SUPPLEMENTAL FINAL ENVIRONMENTAL
IMPACT STATEMENT

ALBANY PORT DISTRICT COMMISSION
PORT OF ALBANY EXPANSION PROJECT

TOWN OF BETHLEHEM, NEW YORK

Date: February 2022

Figure 2.3-1:

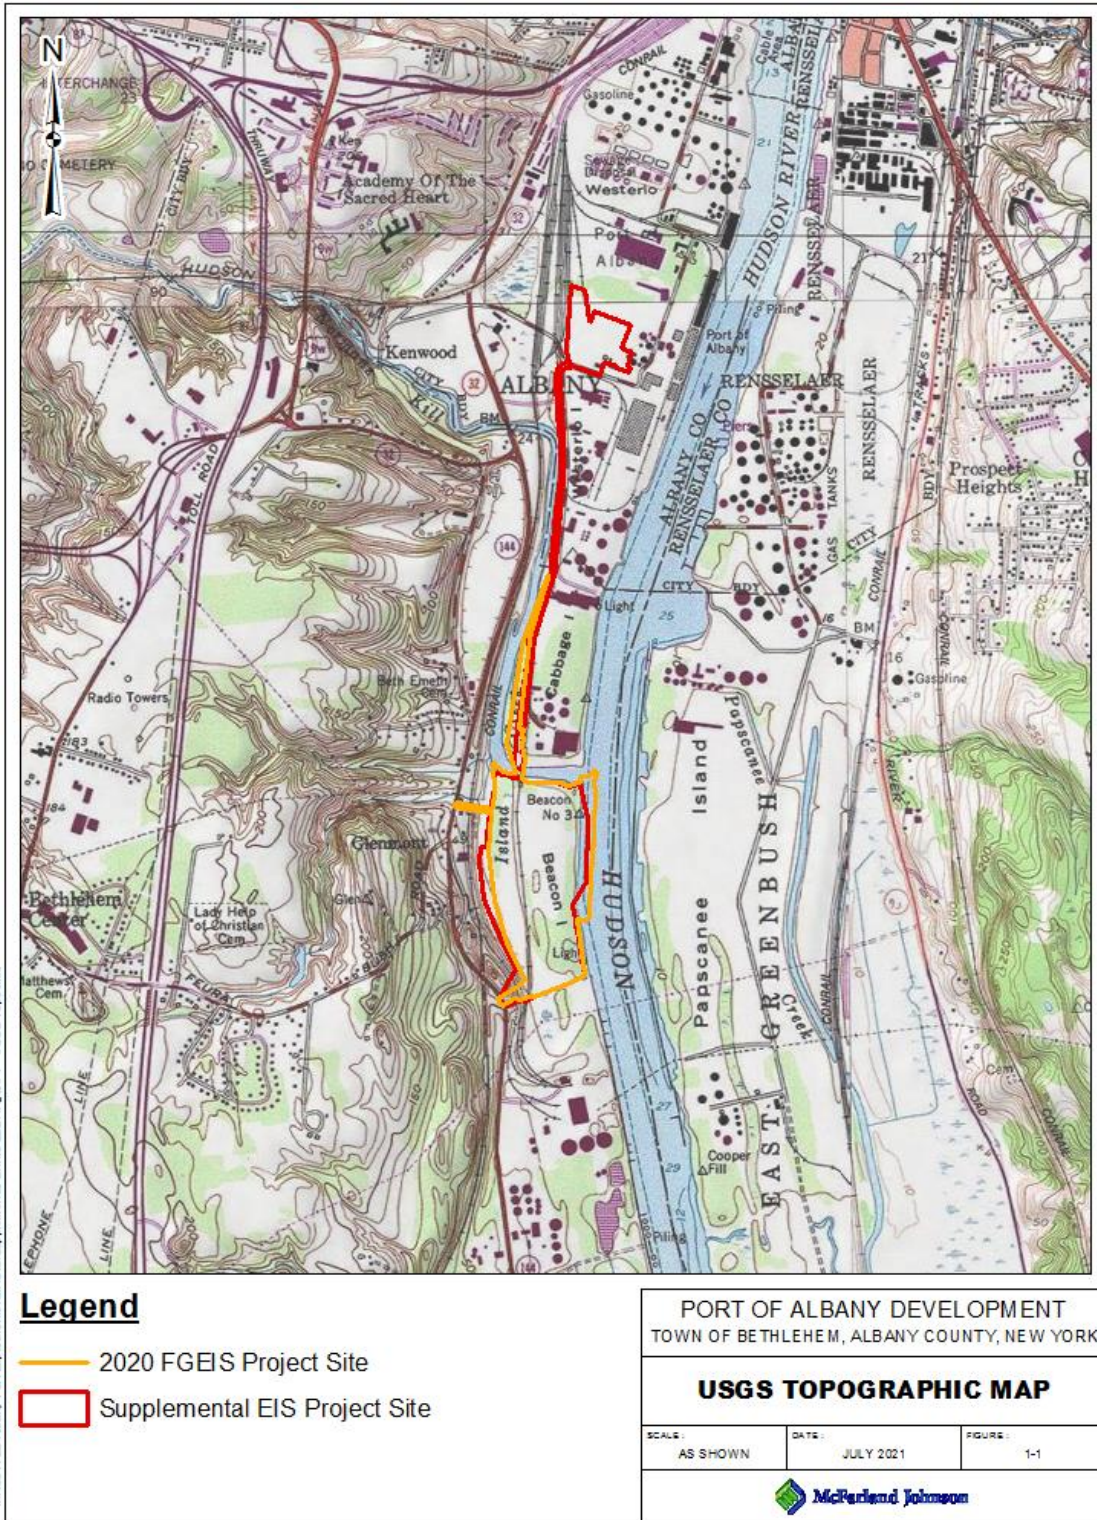
Comment A-3: Figure 2.3-1, and similar figures throughout the SDEIS, are confusing, especially where the 2020 Final GEIS Project Site line and Supplemental EIS Project Site line are depicted within the Hudson River. Based on the figure, it appears that the Supplemental EIS Project Site includes some but not all the area in the Hudson River, however, the SDEIS includes statements like, “supplemental Project Areas do not include any lands under water” and “the supplemental Project Area is not located within or adjacent to the Hudson River.” These discrepancies should be clarified in the Supplemental Final Environmental Impact Statement (SFEIS), including updated figures, if necessary.

Figure 1.4.6-1: AERMOD 5 km Modeling Domain and Receptor Grid (Including 17 Discrete Receptors Representing Ezra Prentice)

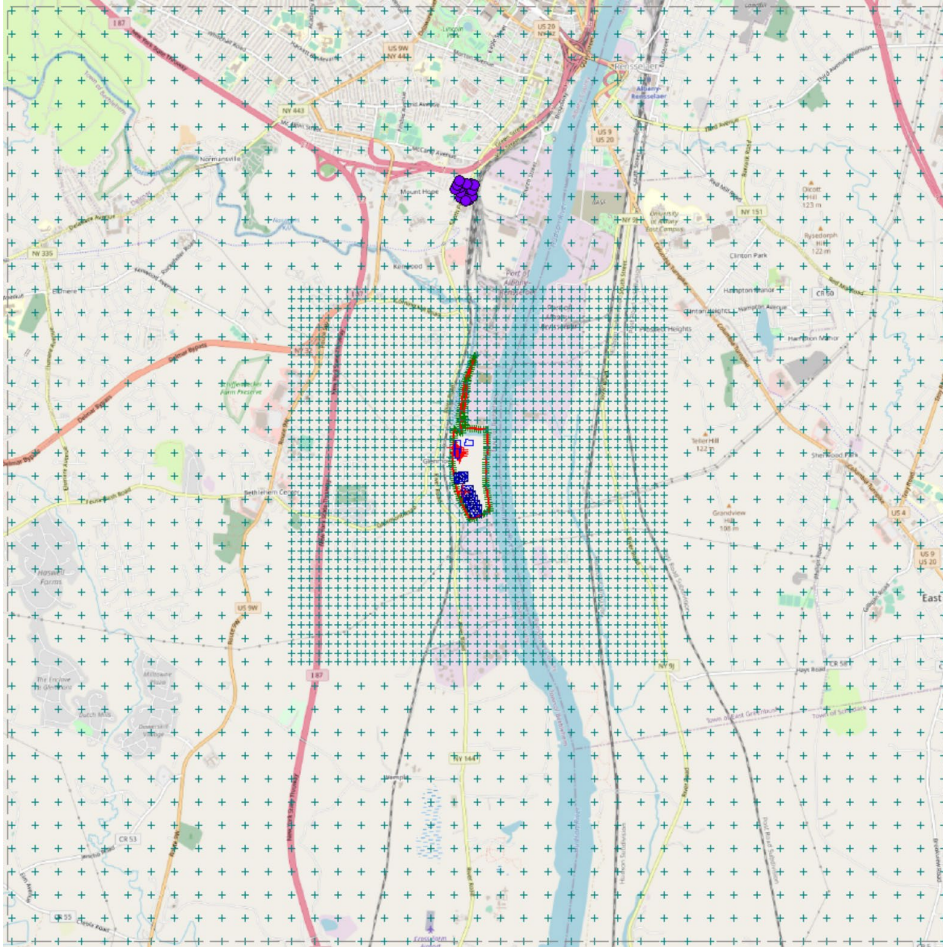
Commented [NYSDEC15]: When the air application is submitted, it must include a protocol outlining the steps taken to model offsite concentrations if AERMOD is going to be applied. The protocol should include the details of the criteria pollutant modeling in addition to the non-criteria. If AERMOD is to be used, the protocol needs approval by NYSDEC before the modeling details are submitted.

Figure 1.4.6-2: Location of EJ Area (Ezra Prentice) Relative to the Project

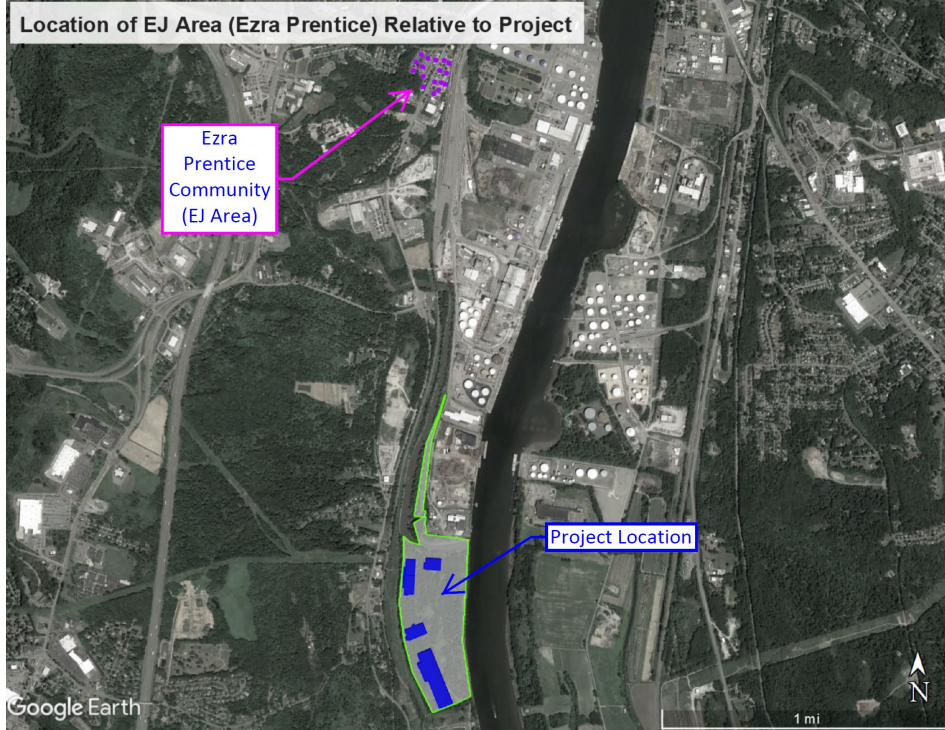
Commented [NYSDEC16]: The Potential Environmental Justice Area (PEJA) Maps should be used. The PEJA area includes Ezra Prentice and extends south of it. The PDF – Supplemental EIS 2021 –10–27-4 final displays the PEJA map in Figure 3.20-1.

Commented [NYSDEC17]: The Potential Environmental Justice Area (PEJA) Maps should be used. The PEJA area includes Ezra Prentice and extends south of it. The PDF – Supplemental EIS 2021 –10—27-4 final displays the PEJA map in Figure 3.20-1.

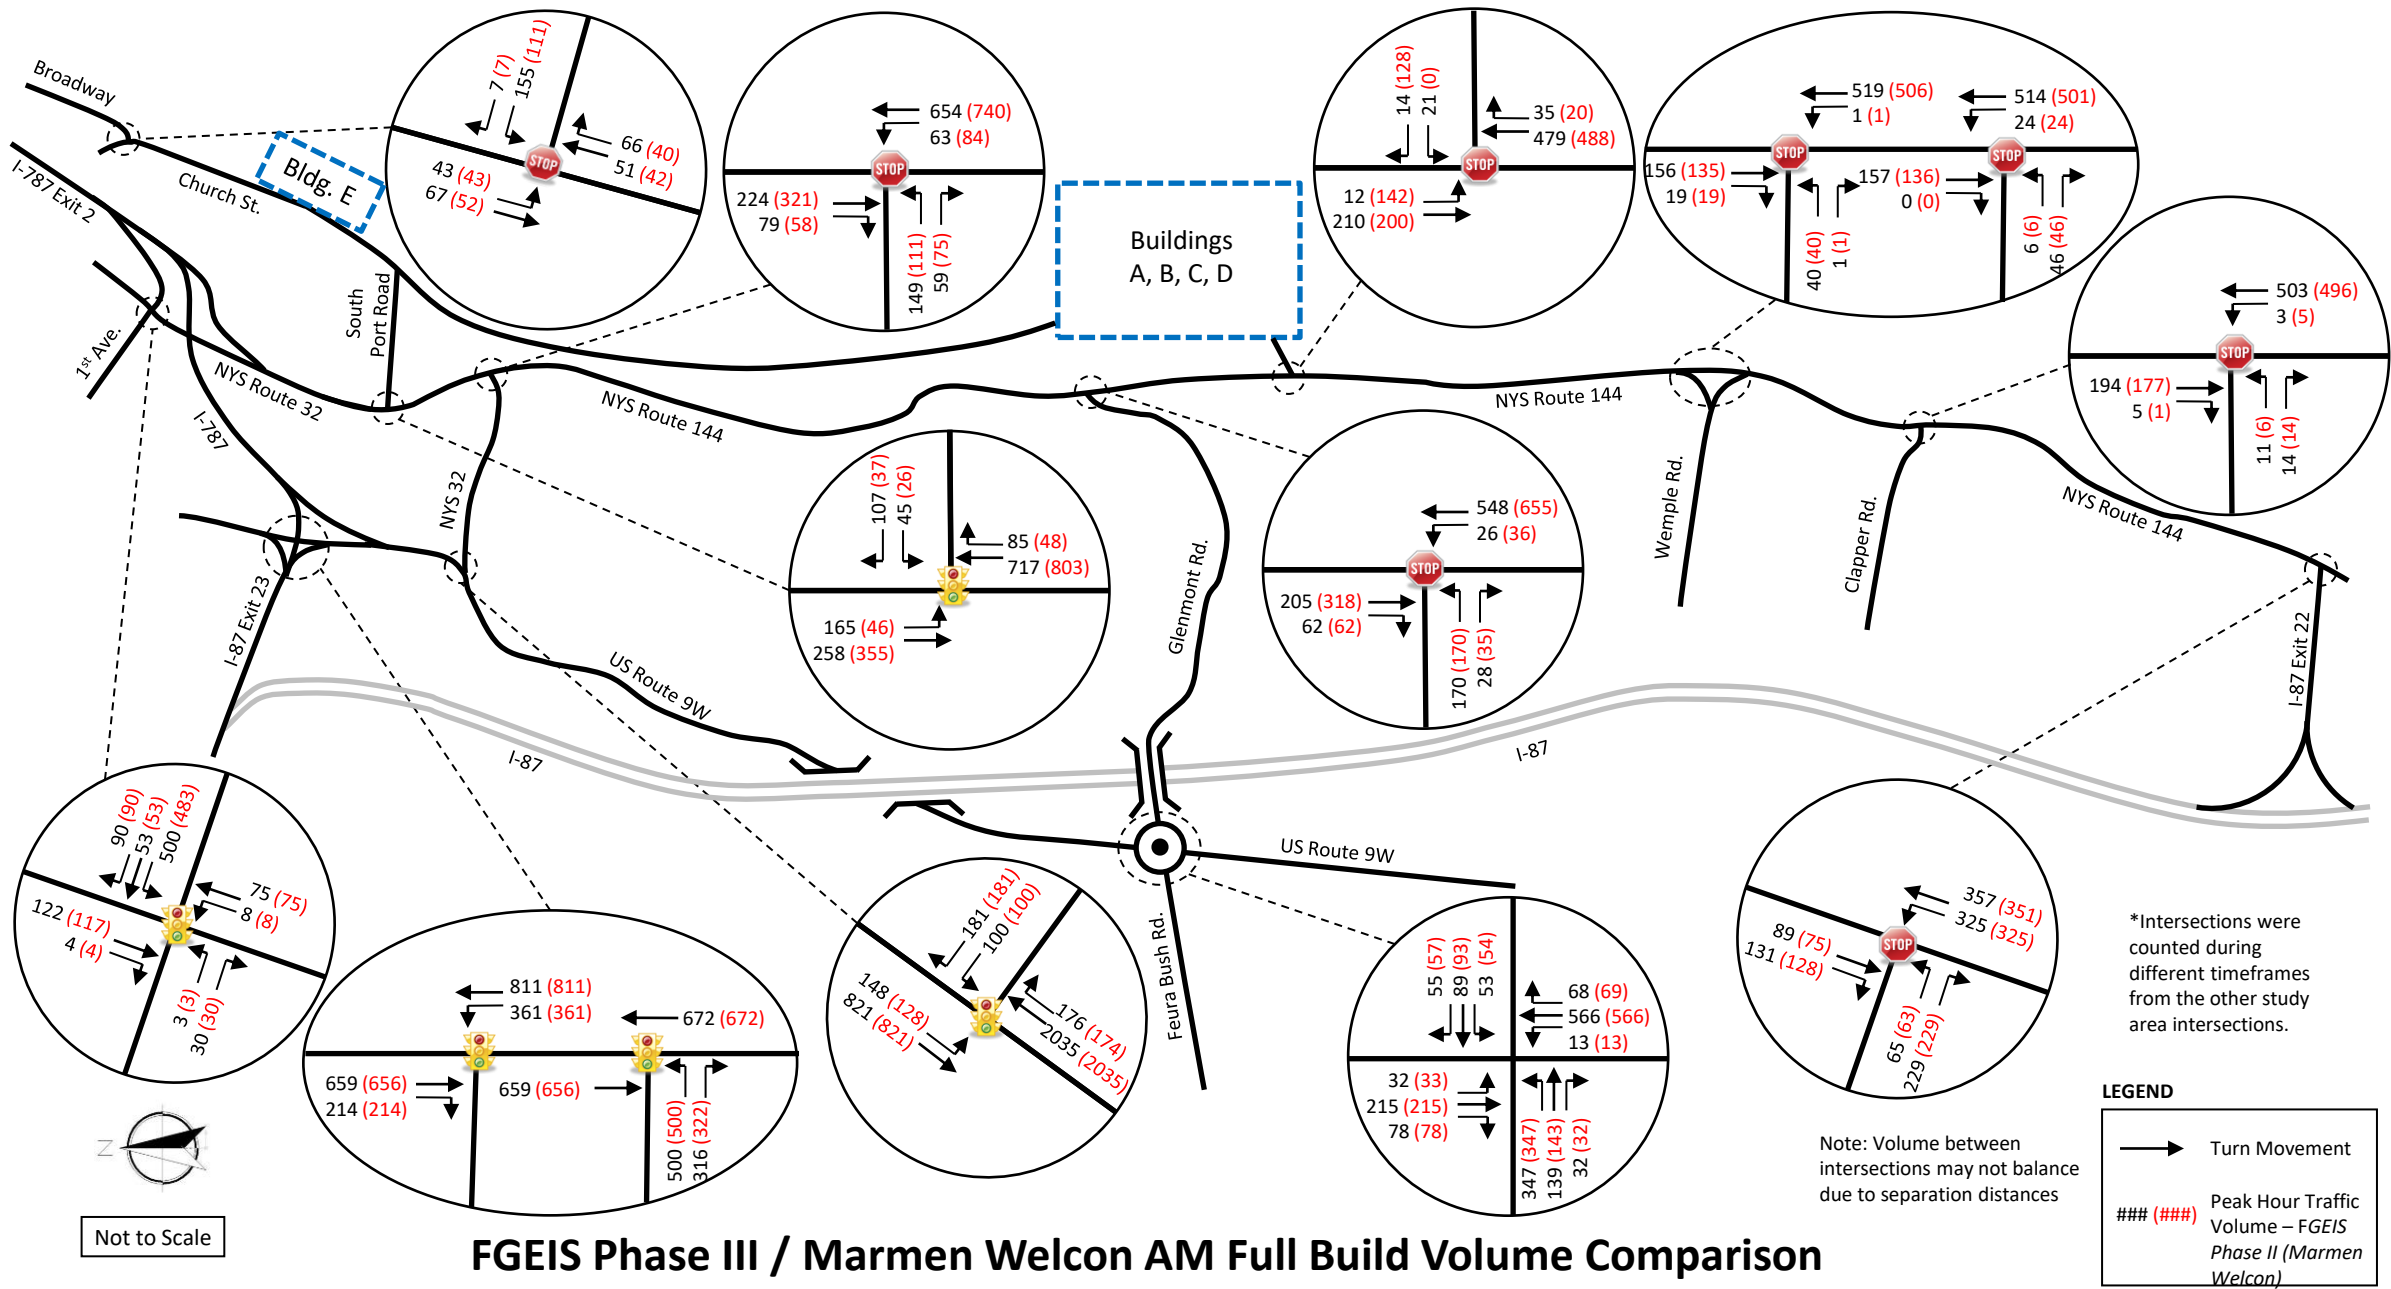
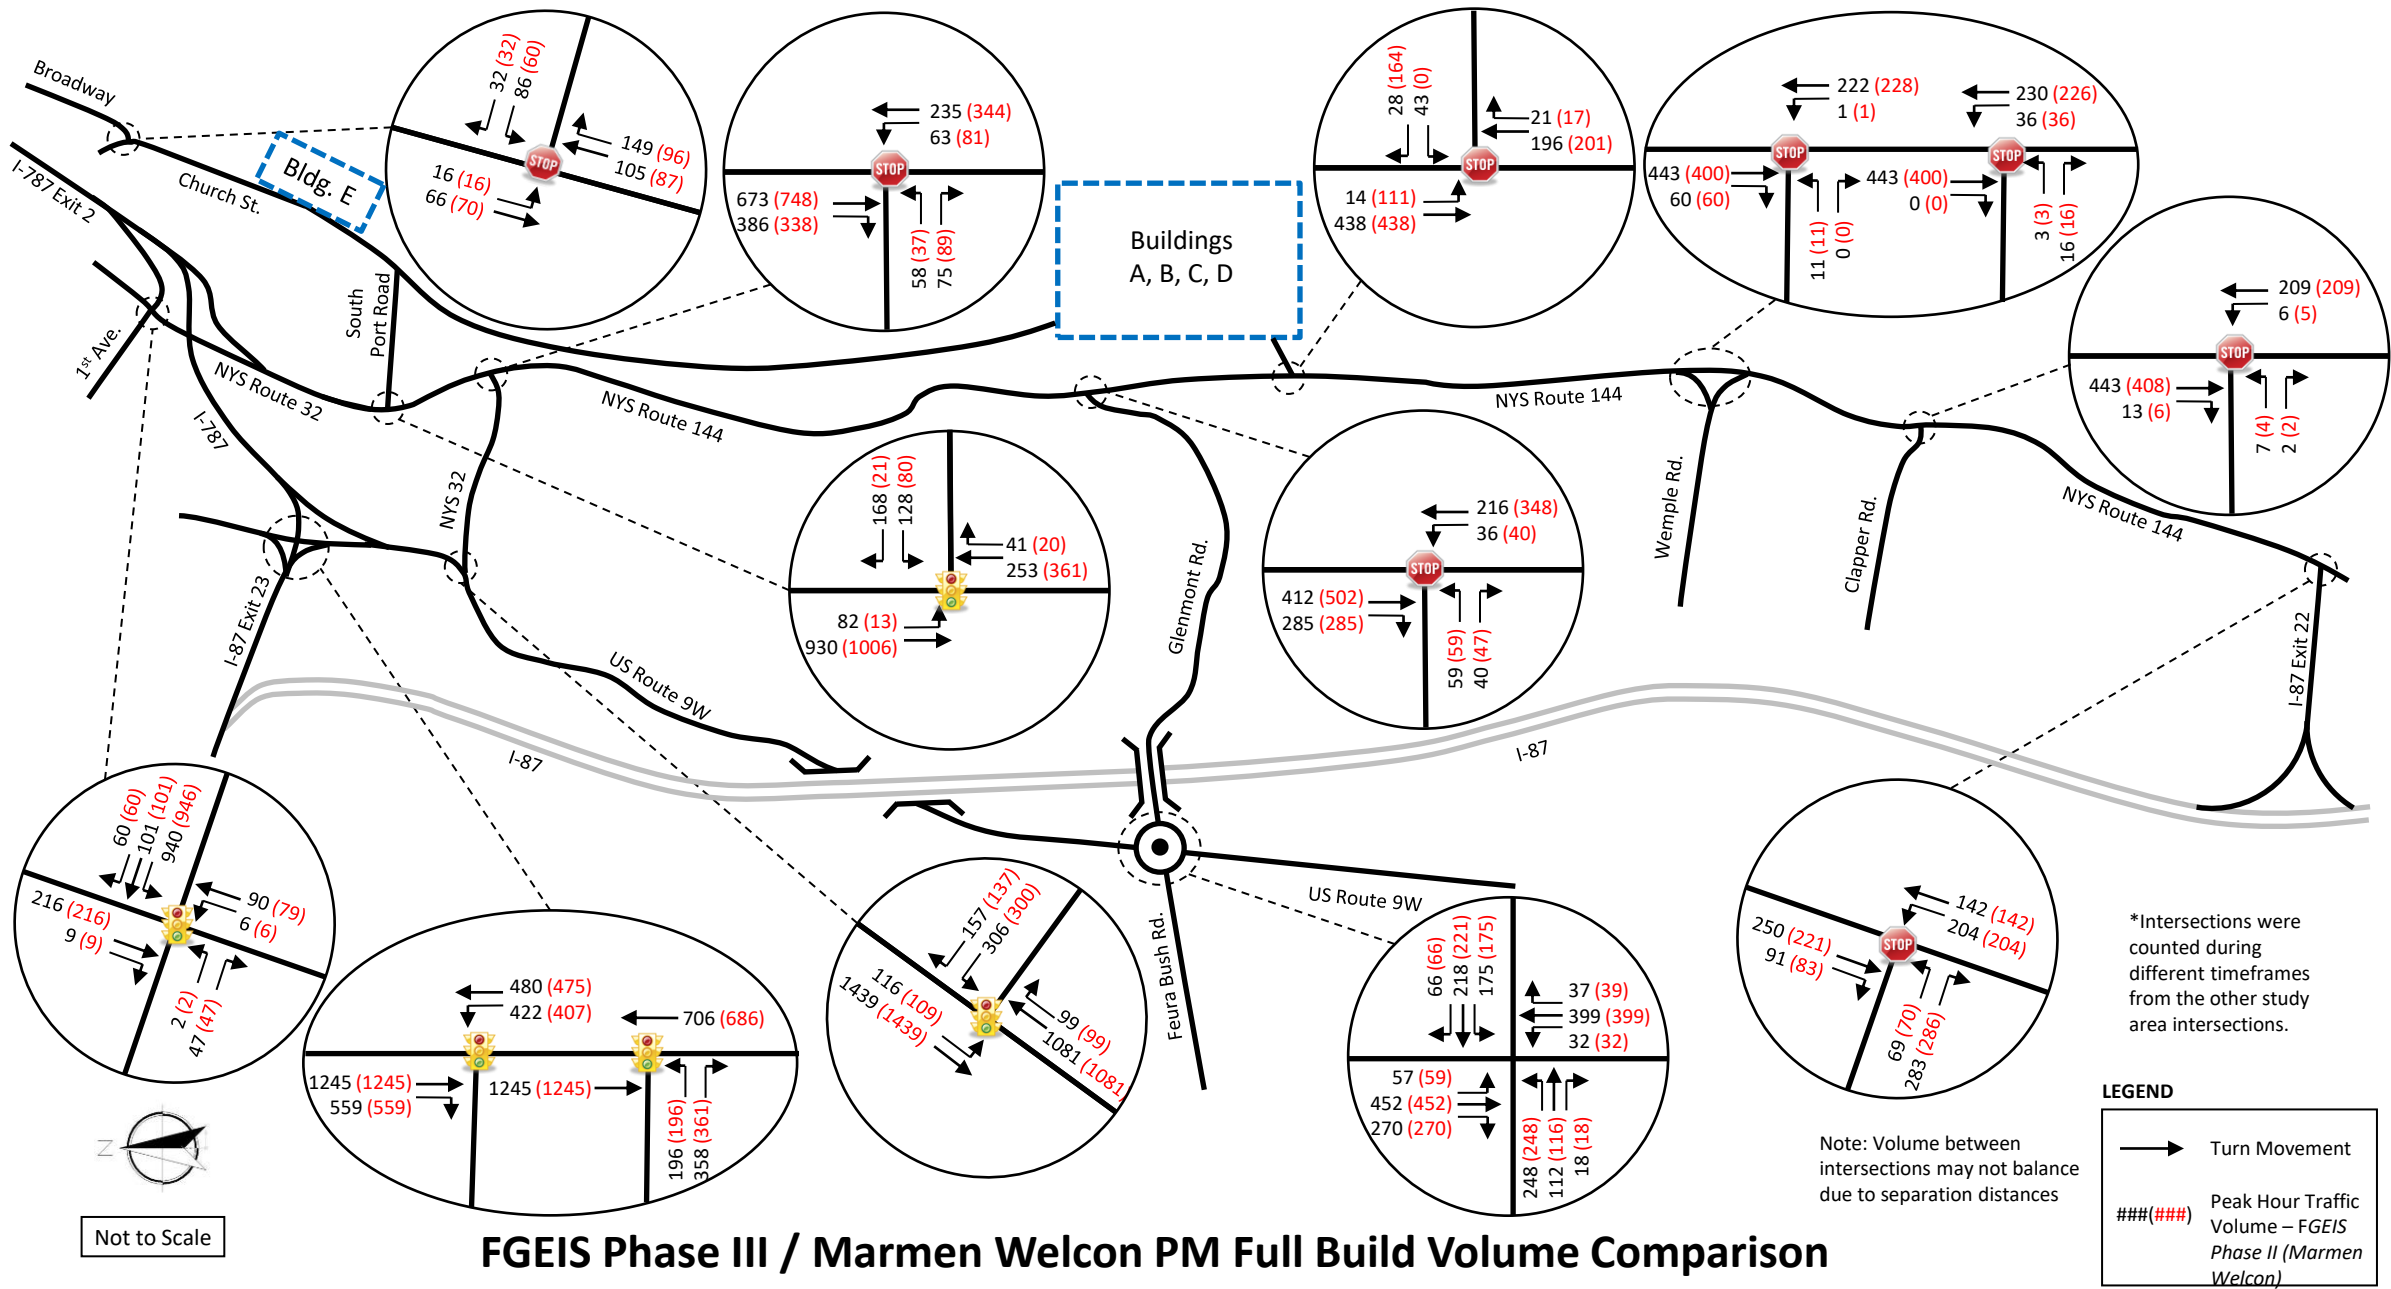
Comment B-5: Figures 2A and 2B: The difference in volumes between intersections along the NYS Route 32 and 144 corridor do not match. It is understood the volumes will not balance due to data collected at different times, but the differences should match if all that has changed is the trip volumes. Volumes should be verified and updated accordingly.

Response: The volumes in Figures 2A and 2B were updated and are located in Appendix CC. The through volumes at the proposed site driveway on NYS Route 144 were reduced back to the GEIS values to remain consistent with the previous analysis. The revised volumes resulted in a negligible impact to the capacity analysis results as shown in the table below. All the previous conclusions and recommendation within the traffic impact study remain valid.
